**PEKIN LAKE STATE FISH AND
WILDLIFE AREA**

CRITICAL RESTORATION PROJECT

VALUE ENGINEERING STUDY

October, 2002

PEKIN LAKE VS PROPOSAL #1

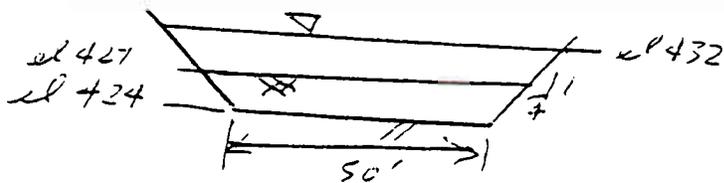
EXISTING SUNKEN BARGE
TO REMAIN DO NOT
DREDGE WITHIN 50 FEET

AVOID DOCKS & CHANNEL FOR MARINA
NO WORK UNDER THIS CONTRACT

"COOPER'S ISLANDS"
PRIVATE PROPERTY
NO MOORING OR FLEETING

NO BOAT ACCESS
LOW BRIDGE

Cost Calculations - Proposal

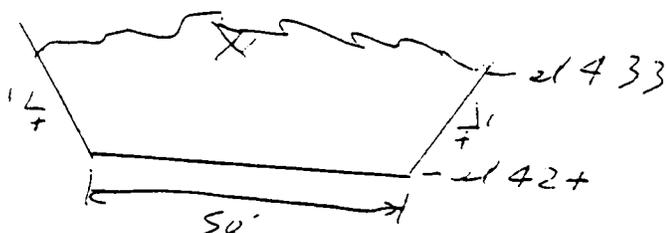
50' additional channel
(more than existing proposal)

500' additional channel,
(more than existing proposal)

Total Additional Dredging required -

14,700 cy

Sketch of VE Proposal #4S

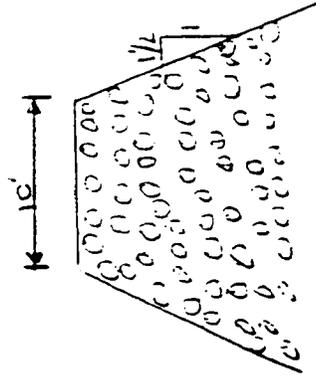
Proposed Change (Show before/after sketches on separate sheets, if applicable): The proposed change is to place an emerged or submerged training structure immediately upstream of the mouth of the outlet channel from the lower unit. This structure could be constructed of rock or geotubes filled with sand dredged from the channel. See the attached sketch.

Cost of 100 foot long rock wing dike. Assume average water depth is 5 feet and that the dike is submerged two feet under the surface. Therefore the dike is 3 feet high.

NOTE: Training Structure can be constructed of rock or by filling a gabtube with dredged material.

TYPICAL SECTION ROCK DIKE
